ADDENDUM NO. 2

To the Drawings and Project Manual dated 16 June 2017

**TAS/ADA FIRE MARSHAL
DEFERRED MAINTENANCE PROJECTS
MIDWESTERN STATE
UNIVERSITY**

**FAIN FINE ARTS - FIRST FLOOR - AREA 1D
ELECTRICAL DEMOLITION PLAN**

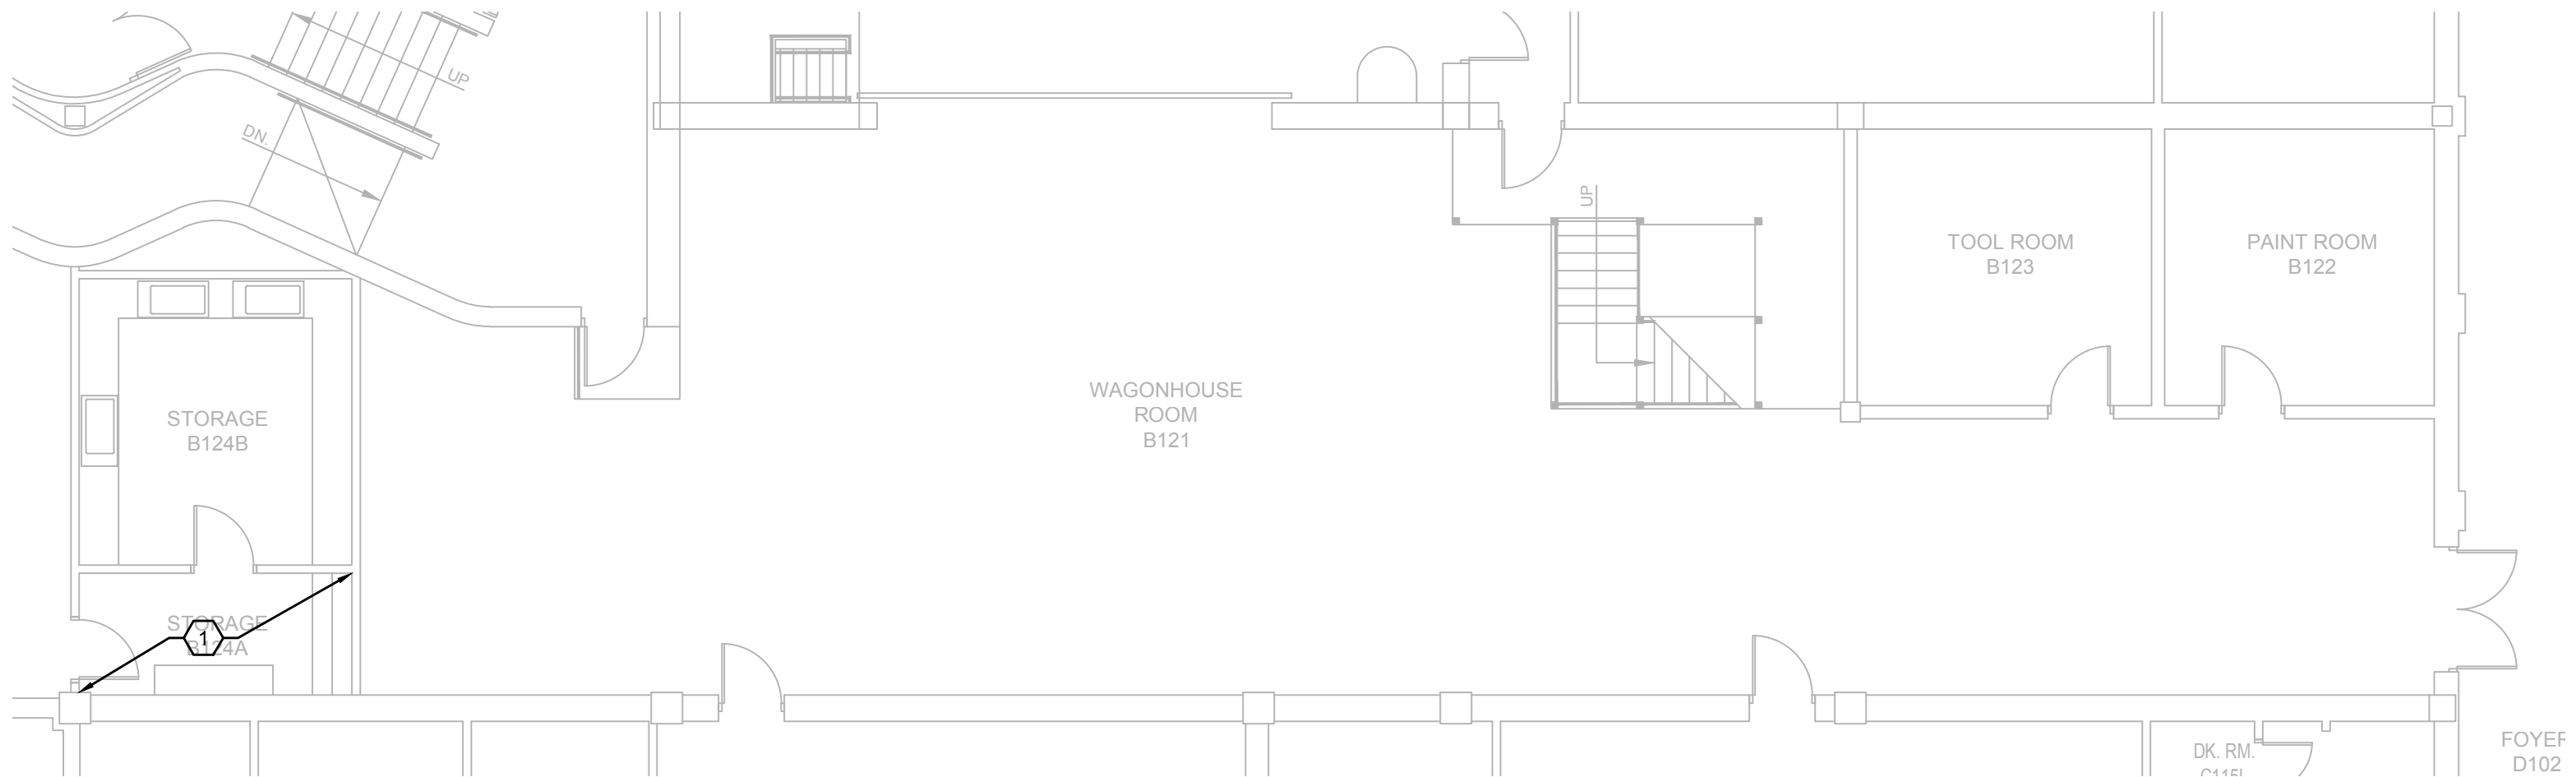
4. Sheet FF-ED102 – Revised Drawing as follows:
 - a. Added Key Note #3 regarding outlets on renovated walls.
 - b. Enclosed the area in the drawing that is covered by Key Note #3.

3. REFER TO ARCHITECTURAL PLANS FOR THE EXTENT OF DEMOLITION IN THIS AREA. FIELD VERIFY LOCATION AND QUANTITY OF ELECTRICAL RECEPTACLES IN THIS AREA. REMOVE ALL WALL MOUNTED RECEPTACLES. RETAIN BRANCH CIRCUITING FOR RE-USE. REFER TO FF-E102.

FAIN FINE ARTS - FIRST FLOOR - AREA 1C
ELECTRICAL PLAN
FF-E102 SCALE: 1/8" = 1'-0"

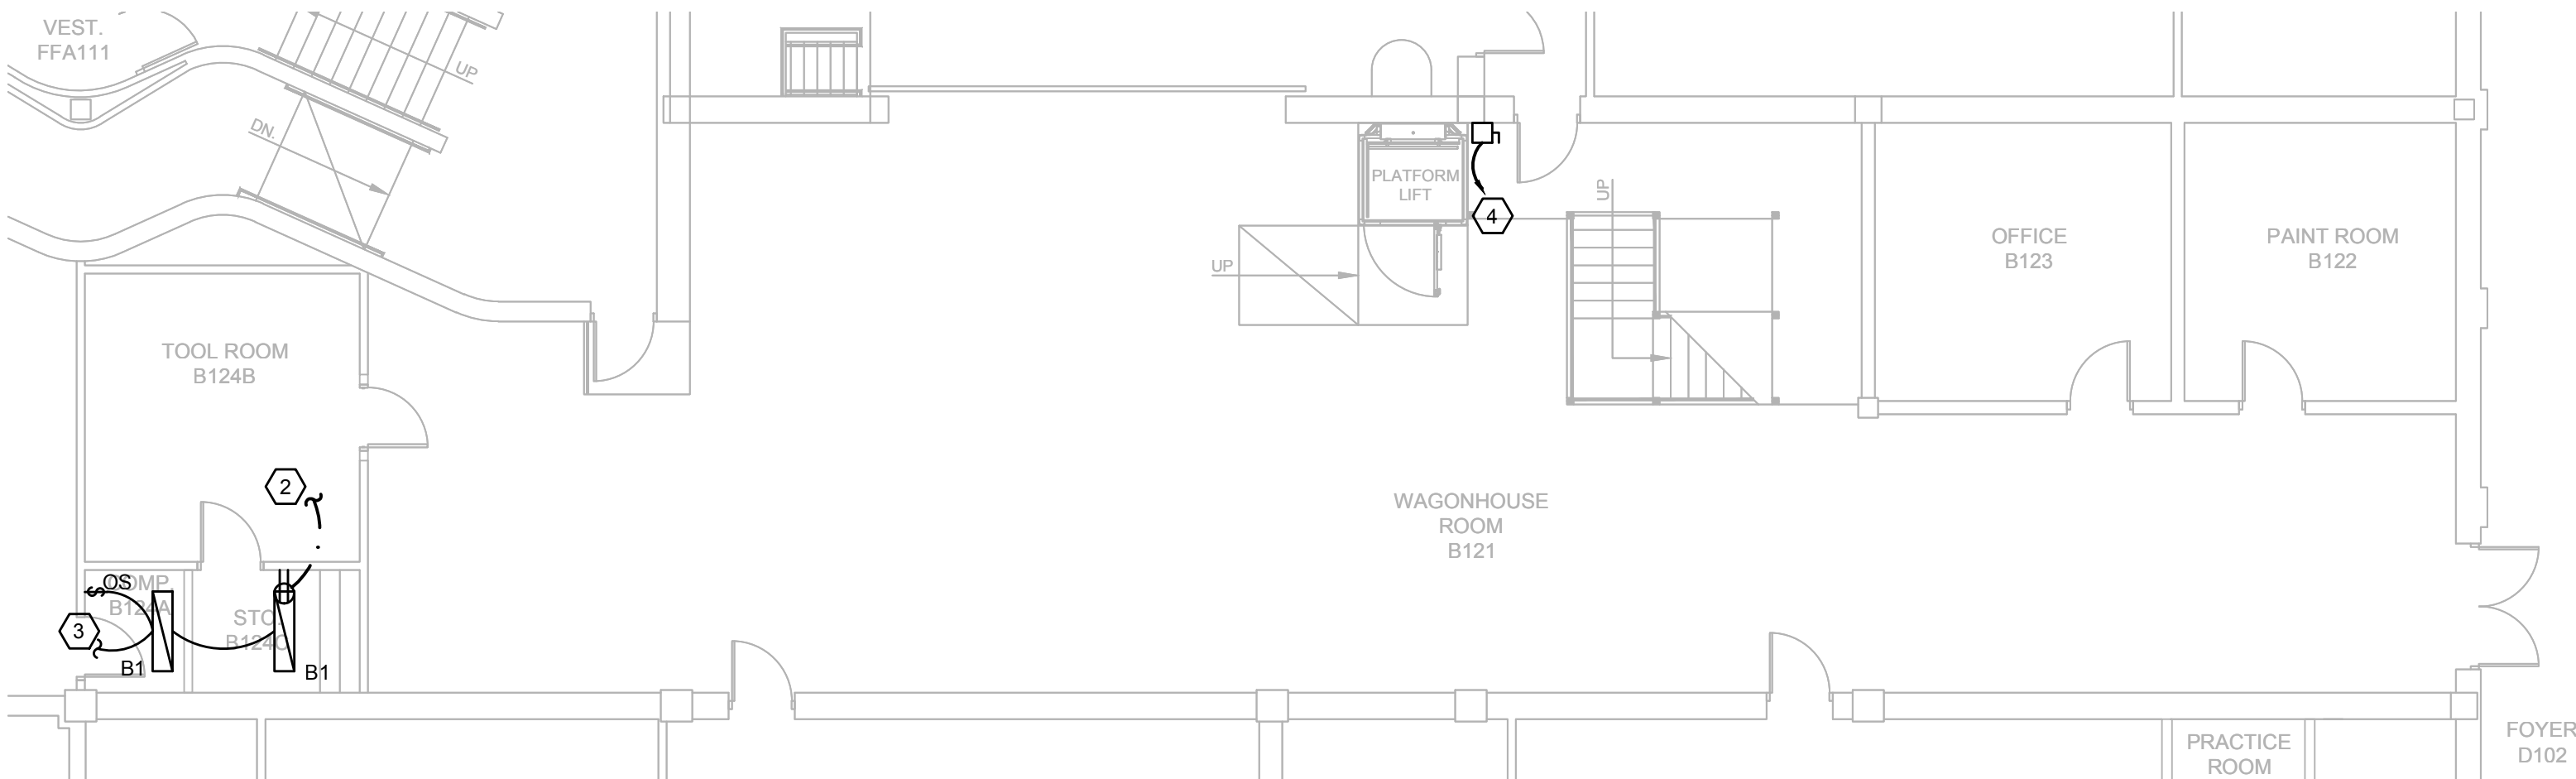
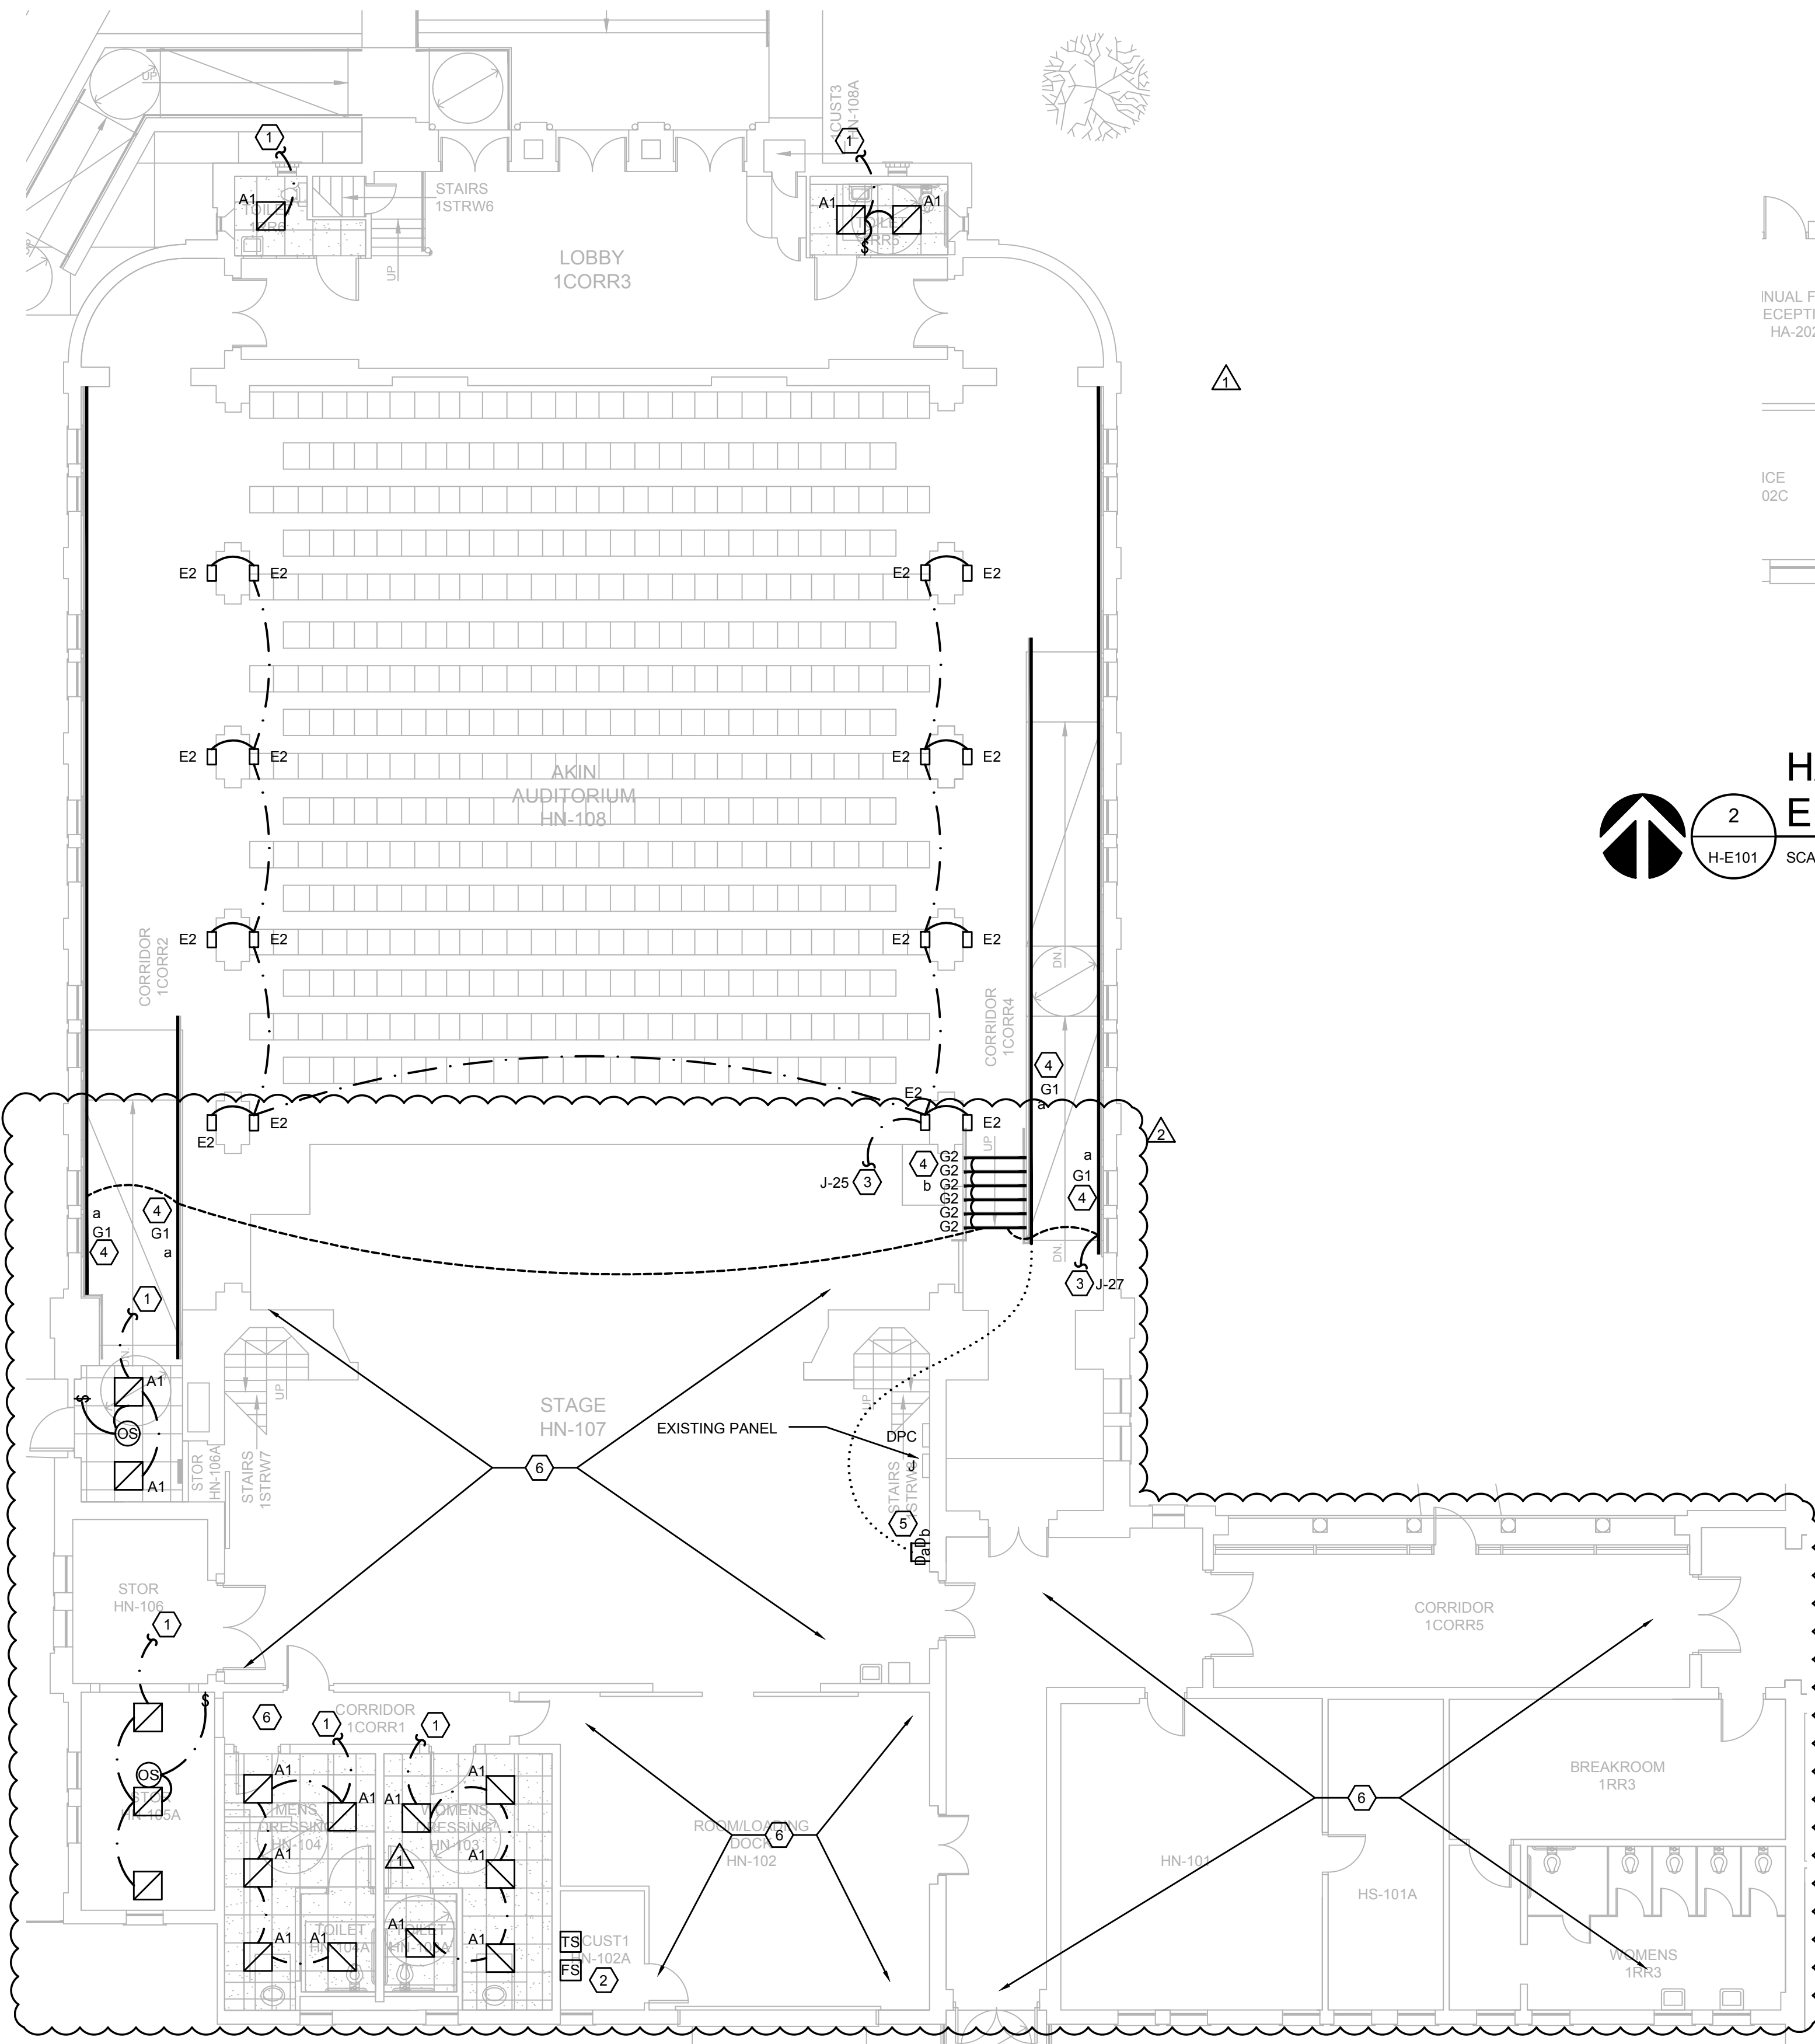
5. Sheet FF-E102 – Revised Drawing as follows:
 - a. Added Key Notes #14 and #15 regarding outlets on renovated walls.
 - b. Enclosed the area in the drawing that is covered by Key Notes #14 and #15.

**HARDIN ADMIN BUILDING - FIRST FLOOR - AREA 1B & 1A
ELECTRICAL PLAN**

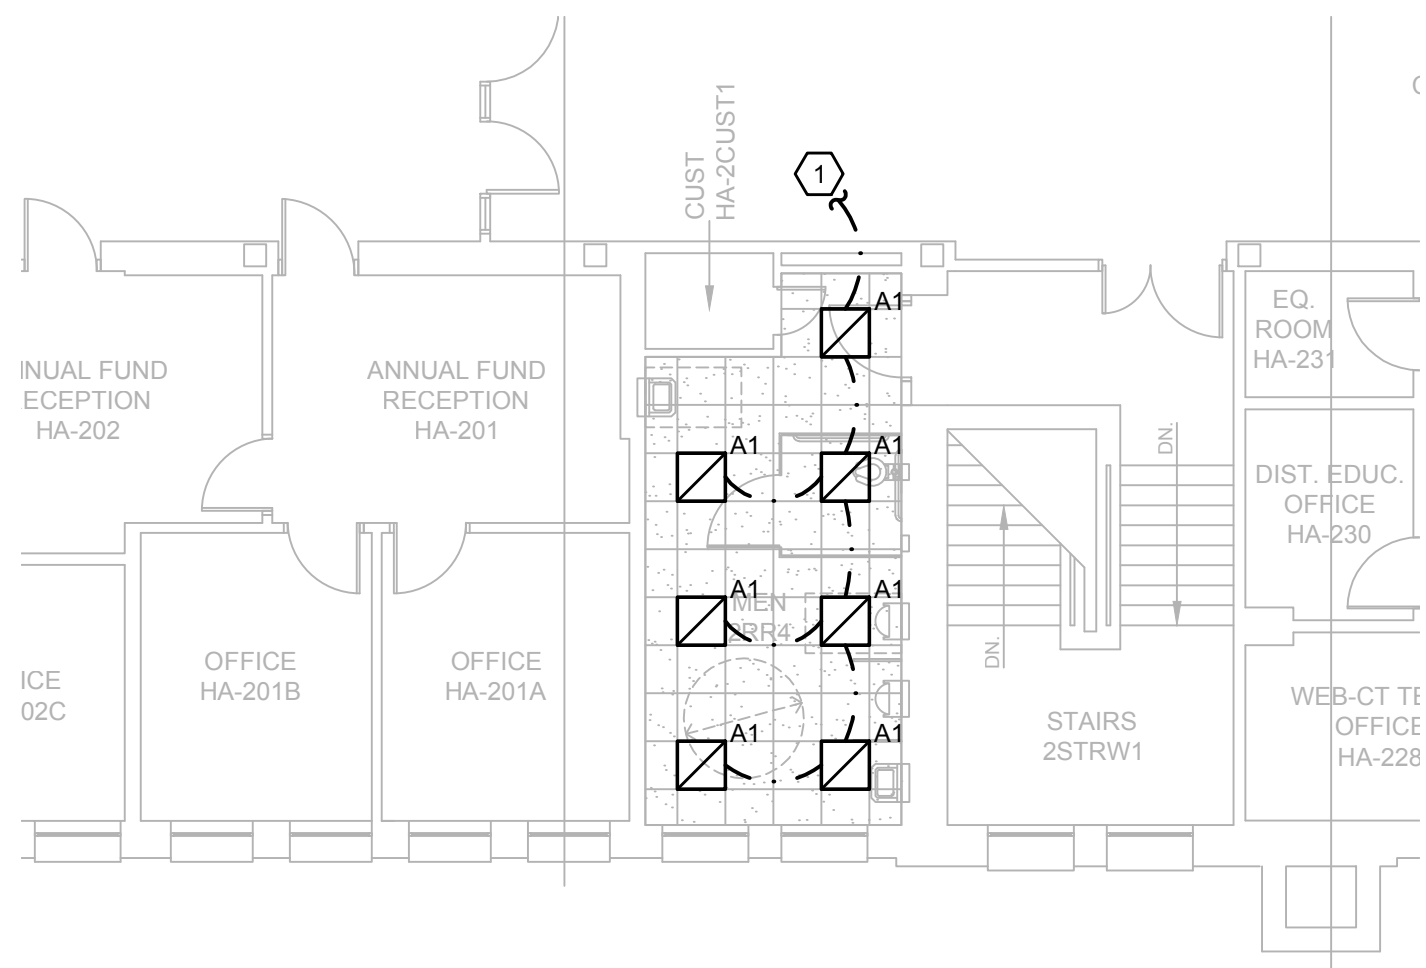
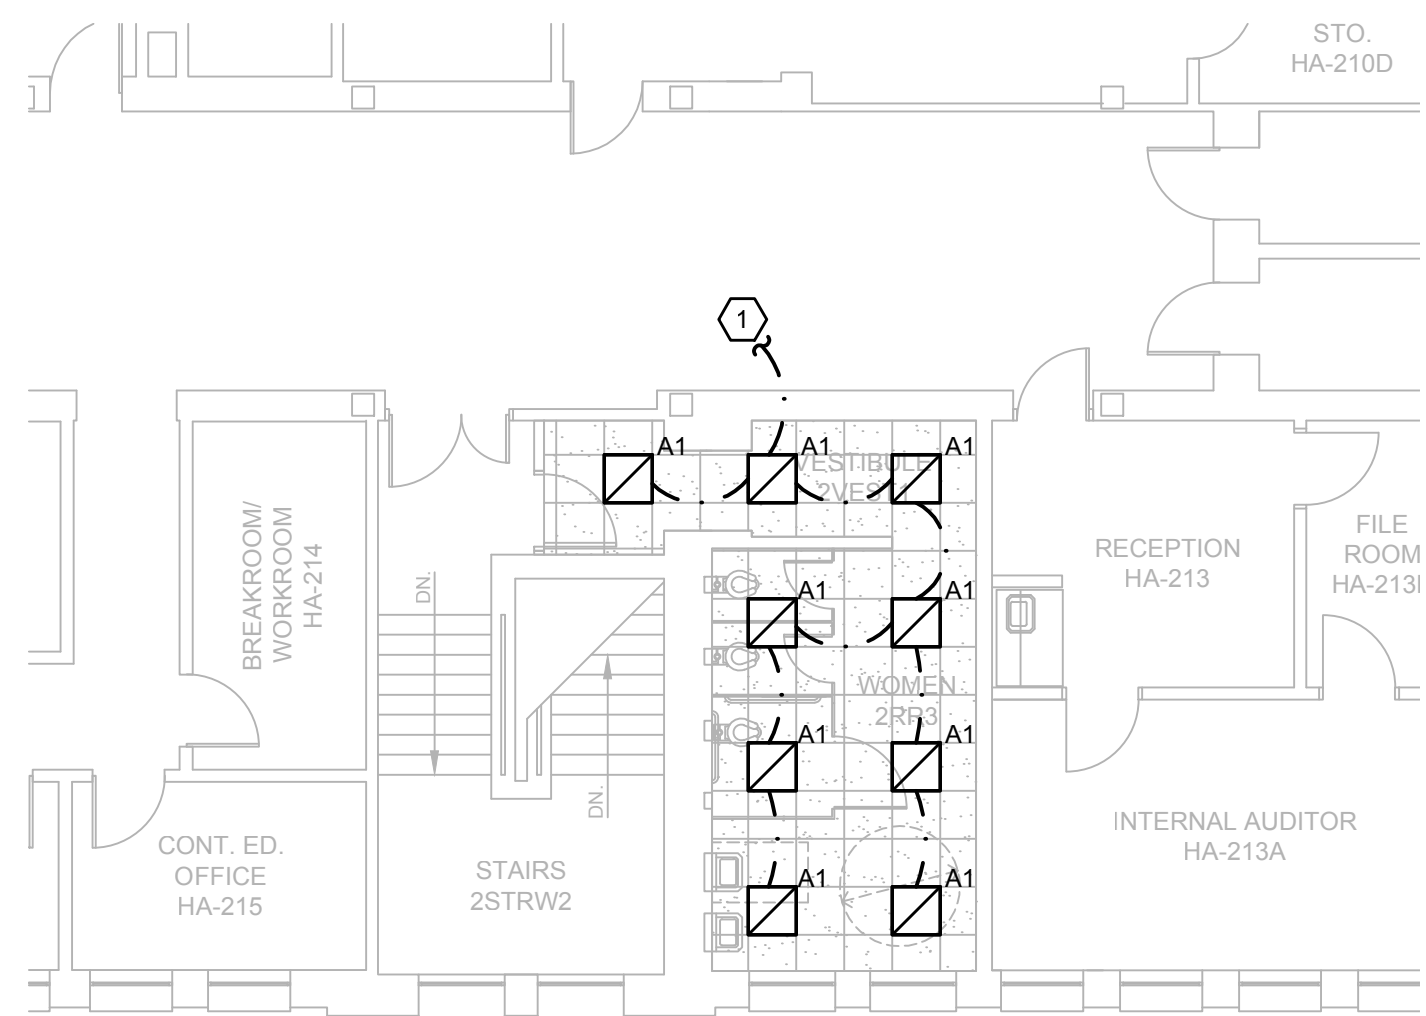
6. Sheet H-E101 – Revised Drawing as follows:
 - a. Added Key Note #6 regarding lighting fixture removal and re-installation on areas affected by fire piping layout.

- b. Add Note Symbol #6 on areas in the drawing affected by fire protection piping installation.

- REMOVE ALL LIGHTS IN THIS AREA AND STORE THEM DURING CONSTRUCTION FOR RE-INSTALLATION AFTER THE SPRINKLER PIPING HAS BEEN INSTALLED. COORDINATE REMOVAL AND RE-INSTALLATION WITH FIRE PROTECTION CONTRACTOR. REFER TO SECTION 260112 "INTERDISCIPLINARY COORDINATION FOR CONNECTION AND RECONNECTION OF OTHER EQUIPMENT. MAKE NECESSARY ADJUSTMENT TO THE WIRING SUCH AS EXTENDING THE CIRCUIT AND ADDING WIRING DEVICES AS ROUTING MAY BE AFFECTED BY THE FIRE PROTECTION INSTALLATION.
